THE LAW OFFICE OF
HEIDI G. CHAPMAN

February 6, 2003

I am writing to you on behalf of the Kings Mill/Morgan Creek Neighborhood Association. Thank you for your attention at the Creekside public hearing on January 22. We appreciate the time the Council is spending to review this application and the request for additional information. We look forward to continuing the discussion on February 24.

■ SITE ANALYSIS

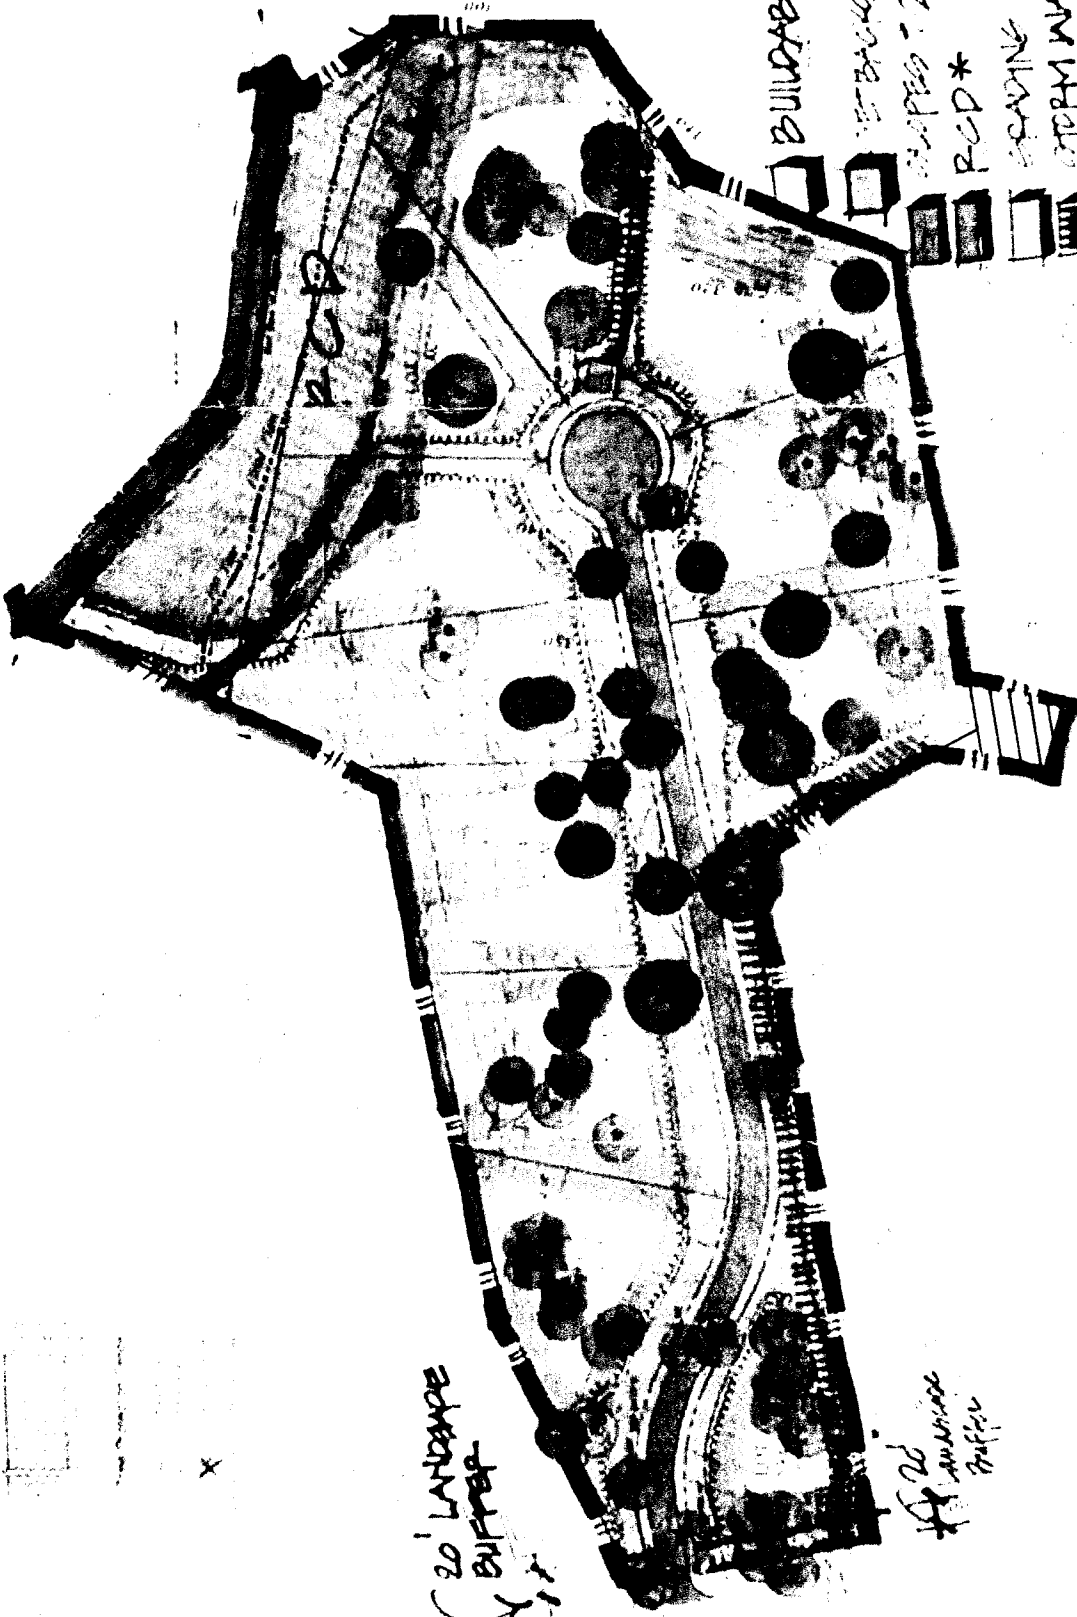
Following up on the Council’s discussion and direction to the staff, we would like to see a re-evaluation of the entire western border of the property to see if the intermittent stream extends beyond the point where the engineering staff determined it ended. We would like to see the engineering staff’s detailed analysis of how this area does, or does not, fit the “intermittent stream field verification criteria” stated in the LUMO.

If this area is found to be an intermittent stream, we believe that the placement of the road needs to be reconsidered. According to the LUMO, see table 3.6.3-2, streets may not be placed within the RCD unless there is a “practical necessity.” There does not seem to be a practical necessity in this case; the road can easily be rerouted.

A finding of an intermittent stream could also seriously call into question whether the area now called Lot 1 can be built on. Additionally, a finding of an intermittent stream in this area would require changes in the applicant’s stormwater management plans.

We have pointed out to the Council the location, including critical root zones, of the many specimen trees on this land. Under this section, the Council clearly has the flexibility to adjust the proposed lots, and the location of the road and utility easements, so that preservation of these trees is maximized.

This section, in fact, requires that the design “maximize the preservation of rare and specimen trees.” Yet, as you can see by studying the attached site map, there is little if any indication that the design has taken into account the location of the many specimen trees. Note in particular the trees marked with an X, indicating that they will have to be cut to clear for the road. **Note that the largest tree on the site, a thirty-five inch oak, is among these trees.** Surely the road could be re-designed so that this tree does not have to be sacrificed.

At the January 22 hearing, a council member asked if the applicant would volunteer to create a hypothetical plat map with nine instead of eleven lots, in the interest of preserving more trees. The applicant declined to do so. We invite you to look at the attached map and think for yourselves about the difference a reduction of two lots could make in terms of the number of specimen trees saved.

In the interest of complying with § 5.7.6(c)(2), we would like the council to consider alternative site plan options.
